ADDENDUM NO. 001

RE: Sullivan County Department of Education –Rock Springs
Elementary School Partial HVAC Replacement
T&L Project No. 17119

DATE: July 20, 2023

This Addendum consists of 6 pages and 2 drawing sheets with the revised date of July 20, 2023.

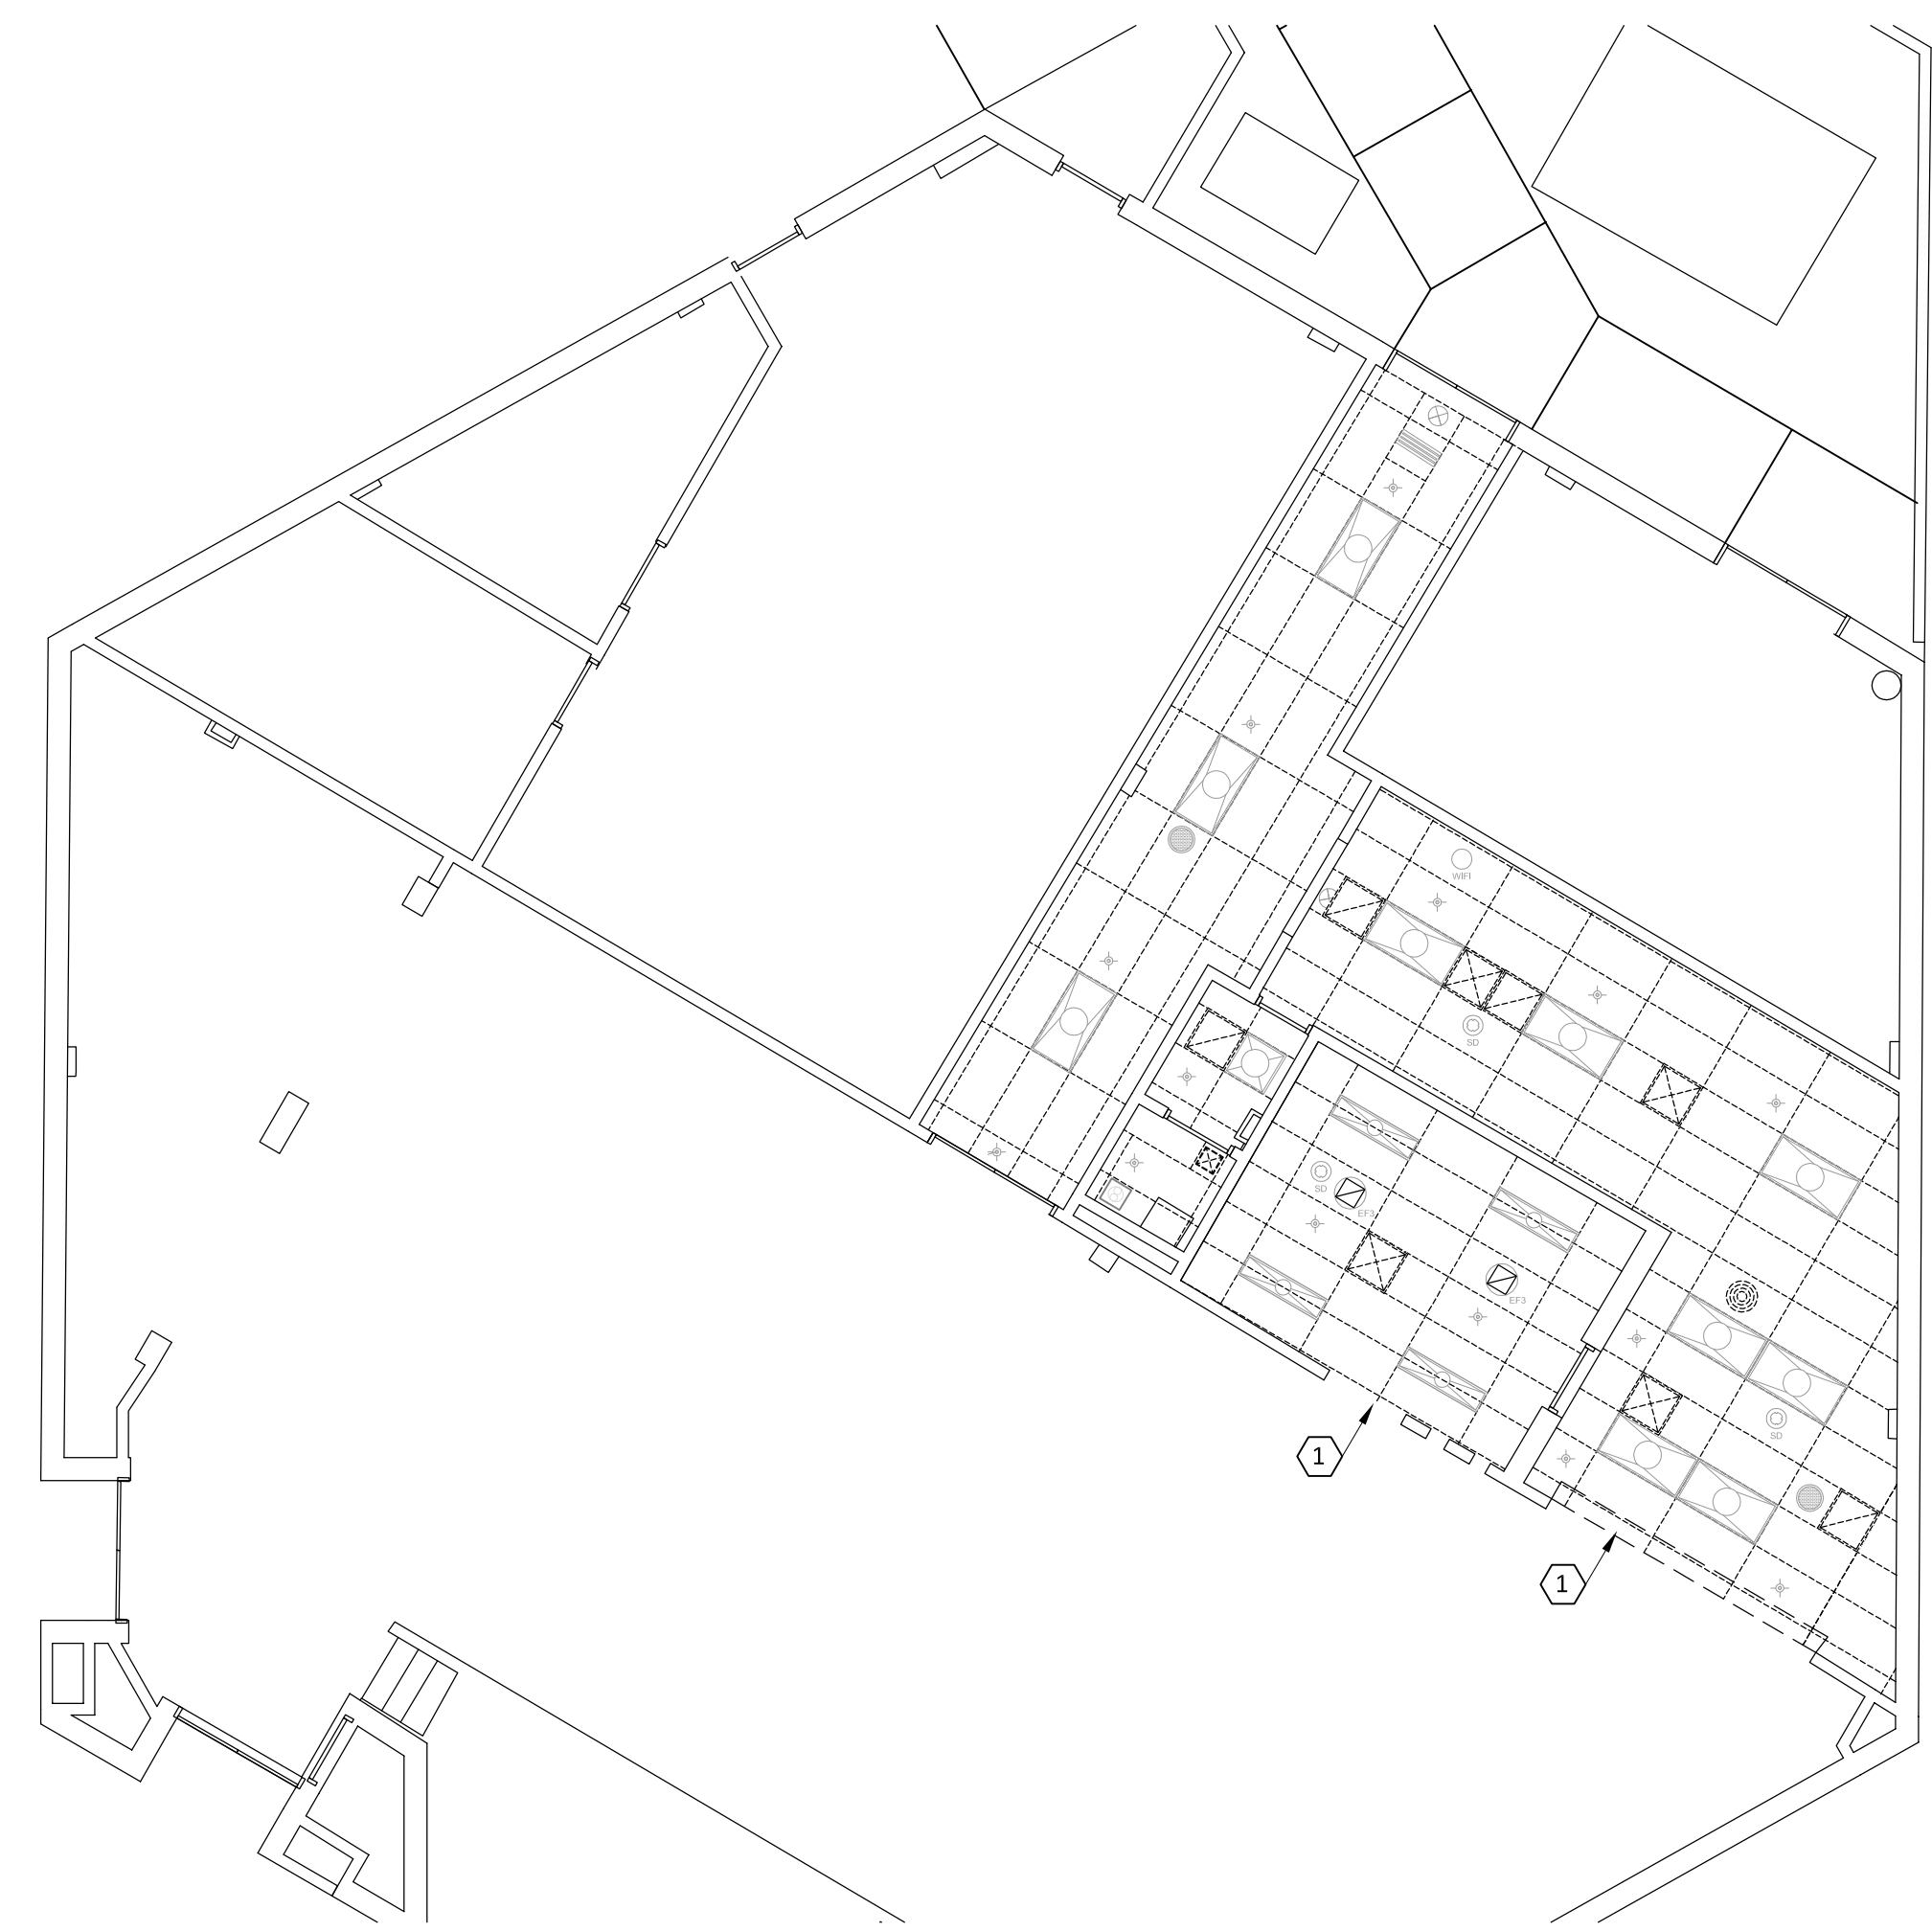
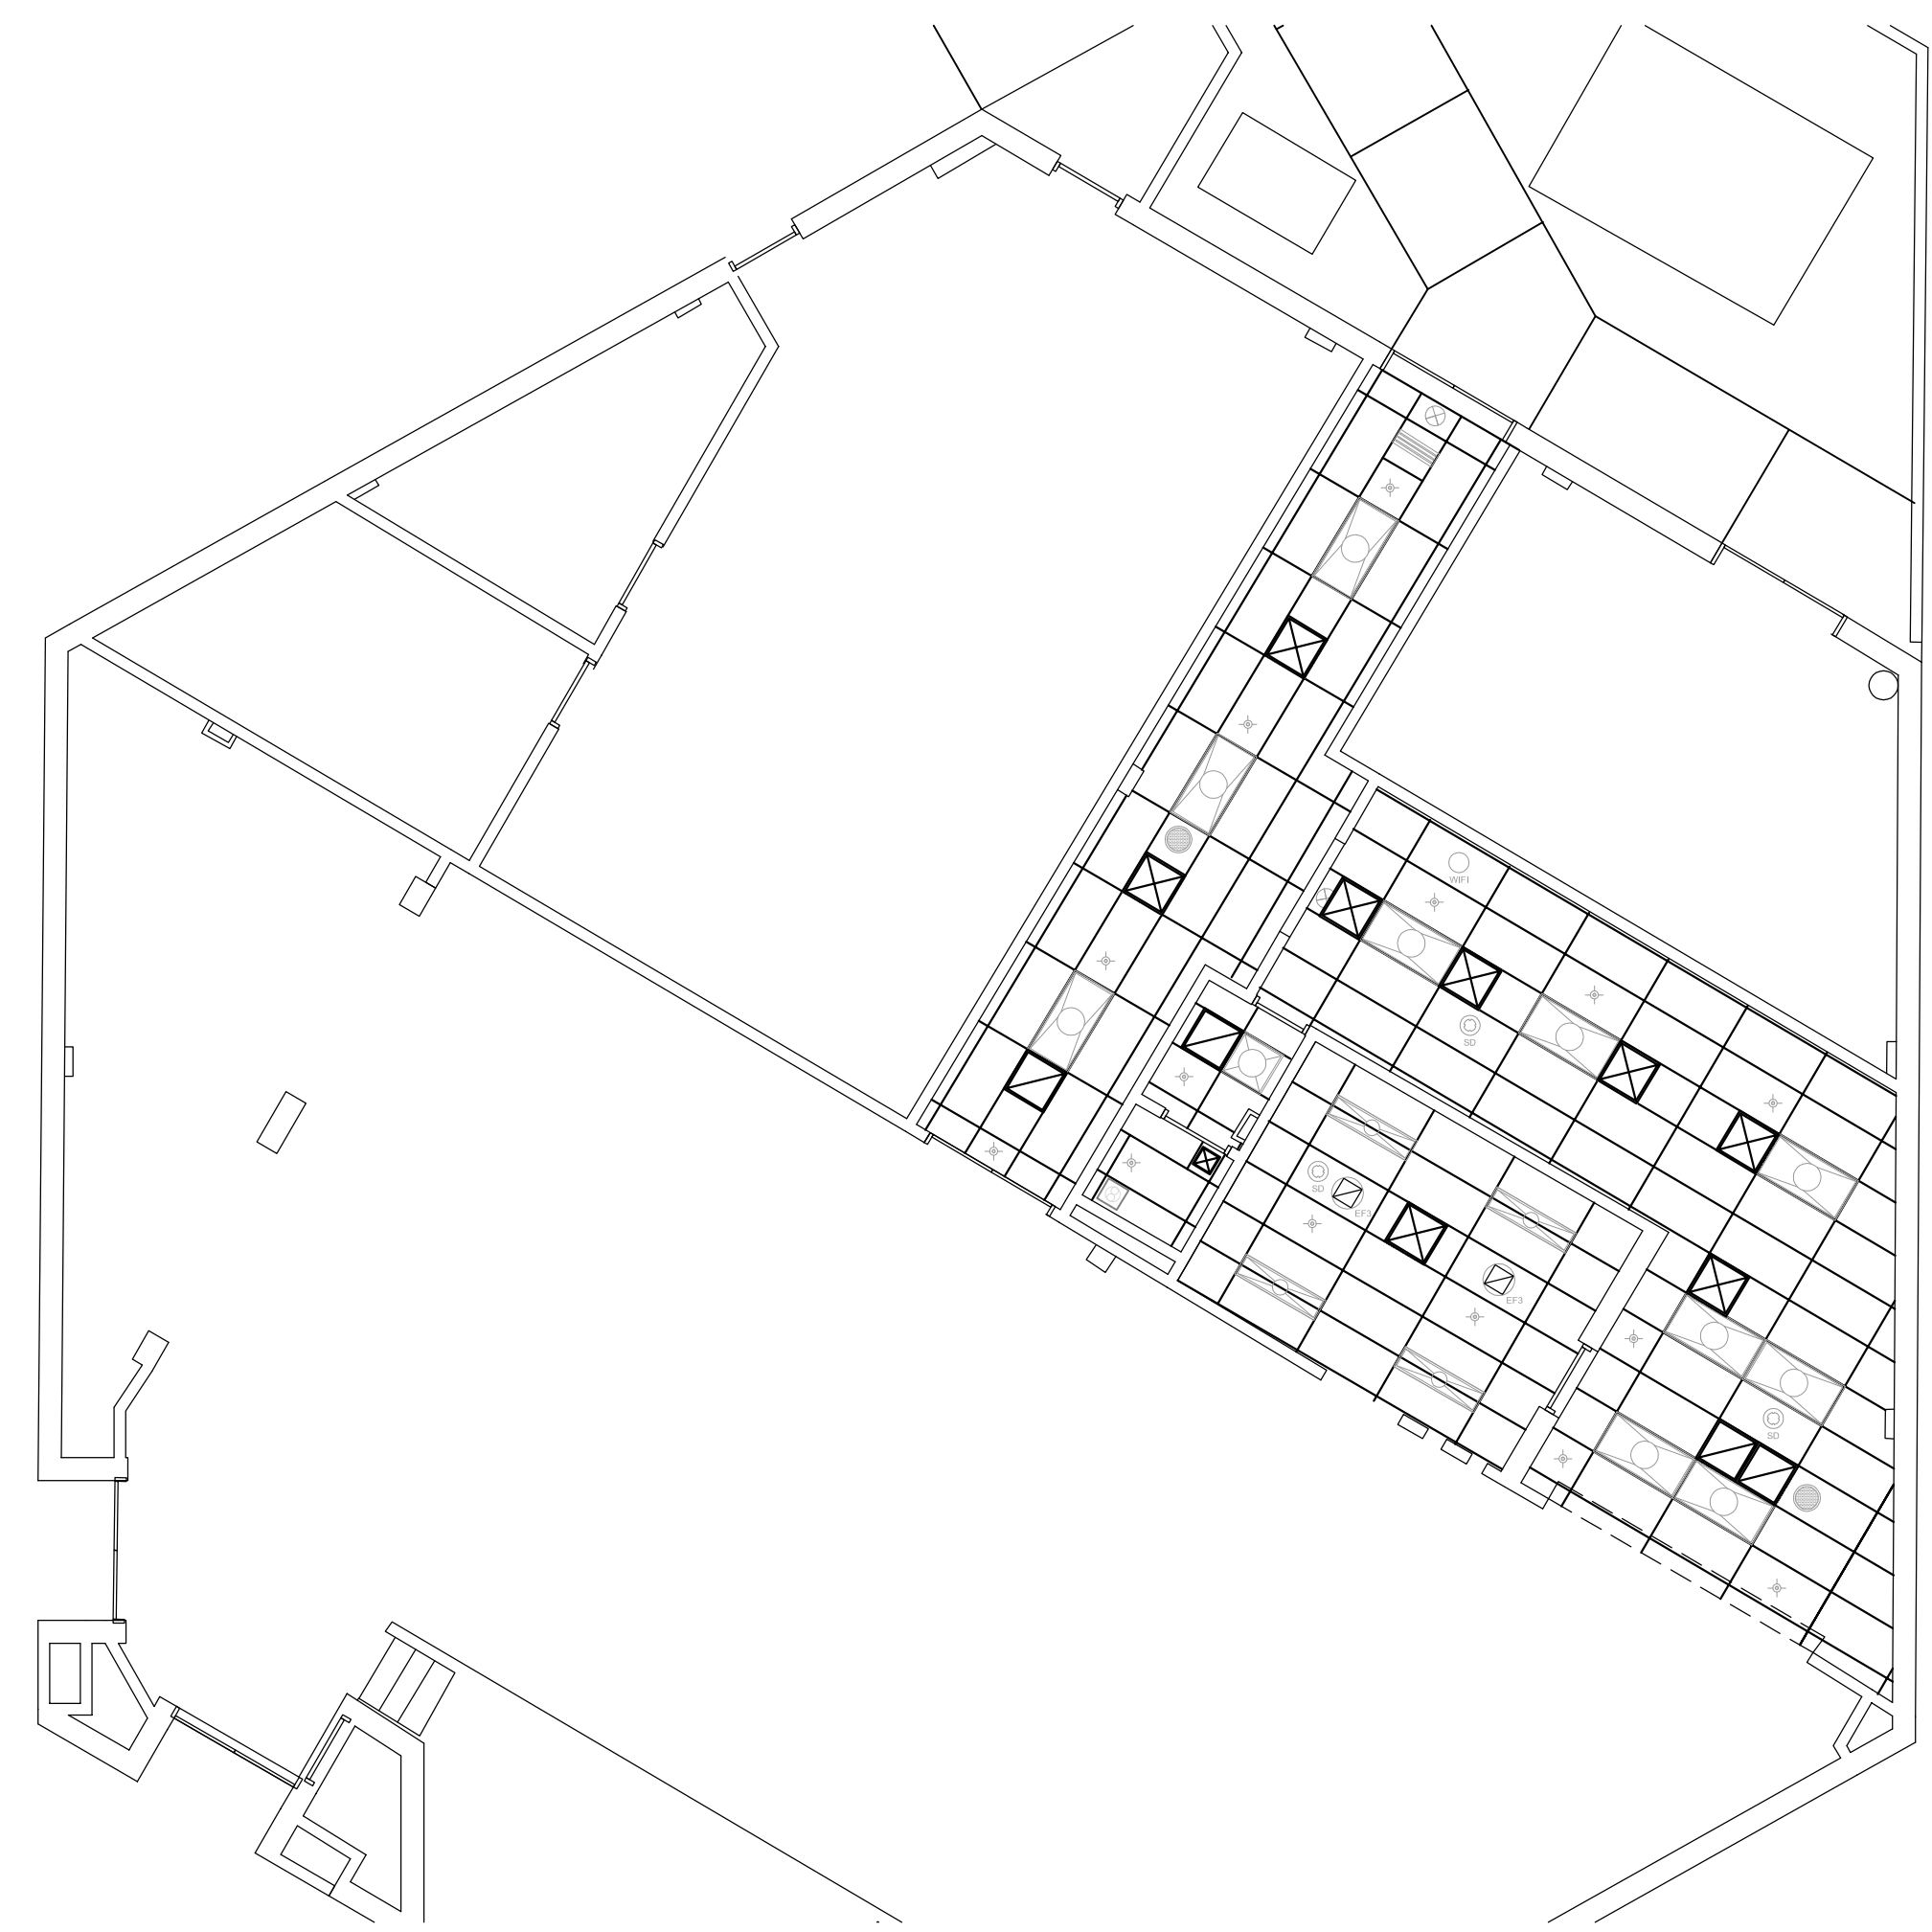
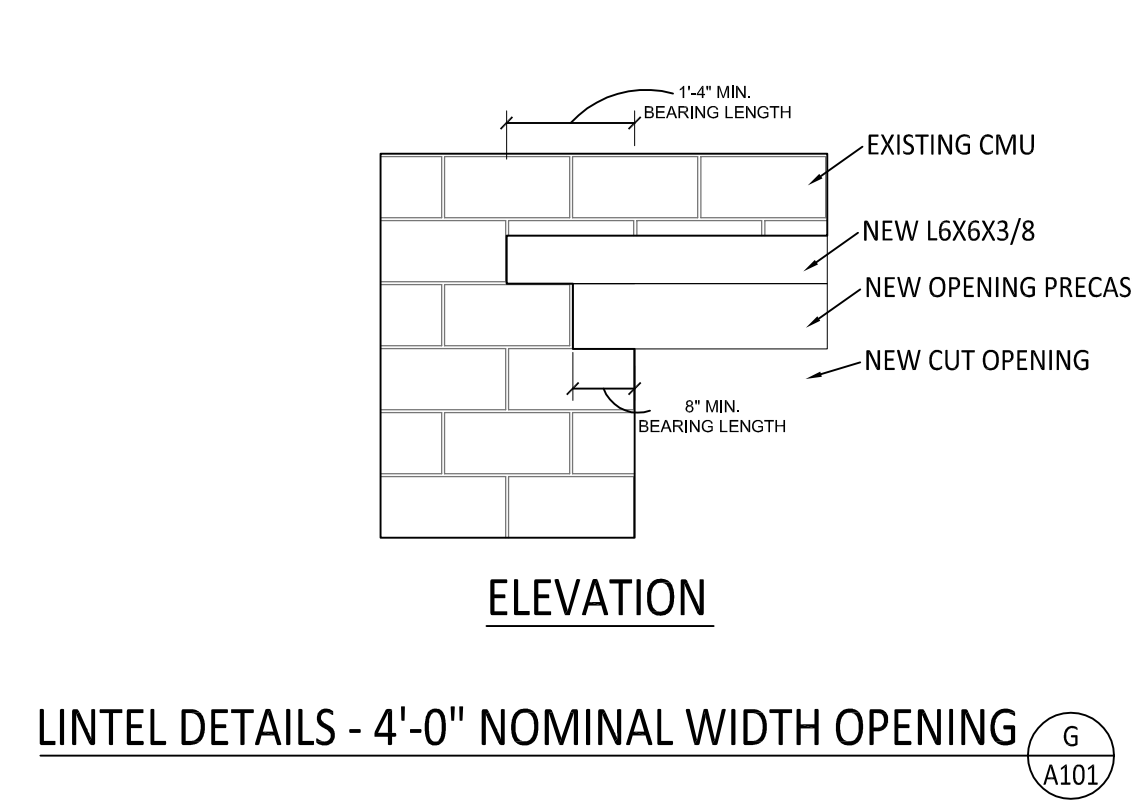
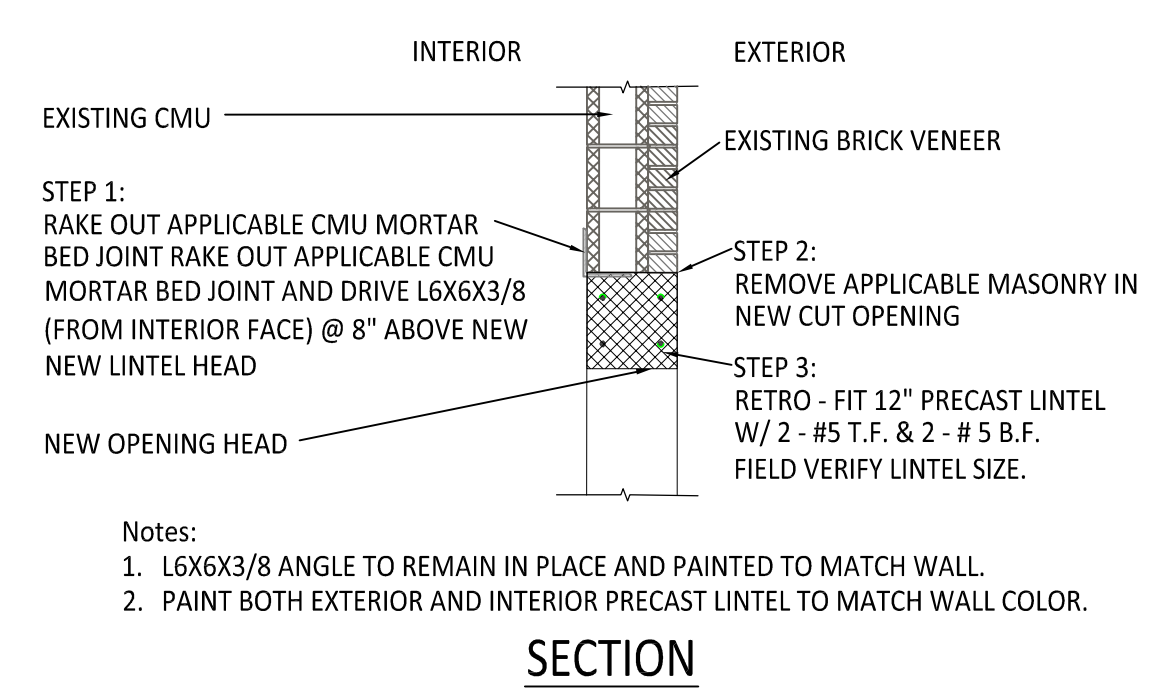
1. Drawing Sheets T001 and A101 are revised with details and notes.
